APPLICATION NOTE 41D

DECREASING THE RESPONSE TIME OF THE MODEL 405 INPUT FILTER

Figure 2.

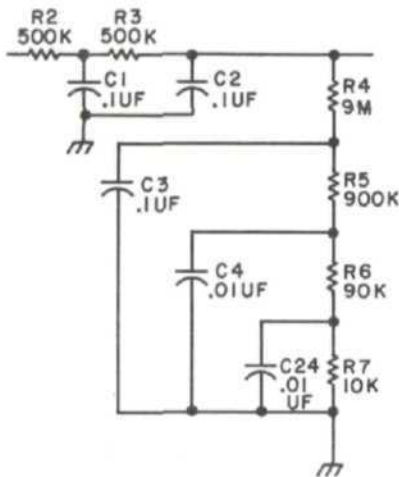
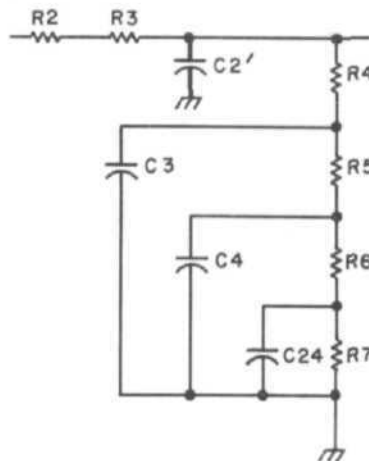
Modification 1 - To reduce the response time on the $\pm .999$ volt range, remove C1 and replace C2 with a $0.01 \mu\text{f}$, 1000 vdcw polystyrene capacitor. For convenience, two $0.02 \mu\text{f}$ 600 vdcw capacitors may be used in series.

Figure 3.

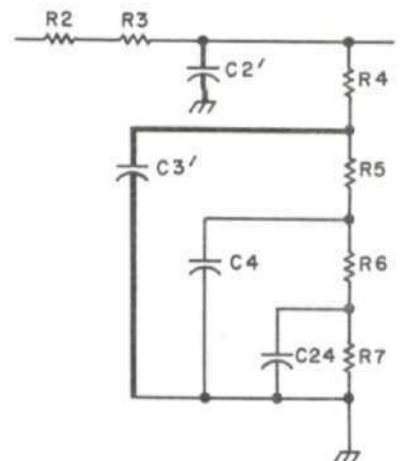
Modification 2 - To reduce the response time on all ranges, perform Modification 1 and in addition remove C3 and replace with a $0.01 \mu\text{f}$, 600 vdcw polystyrene or mylar dielectric capacitor.
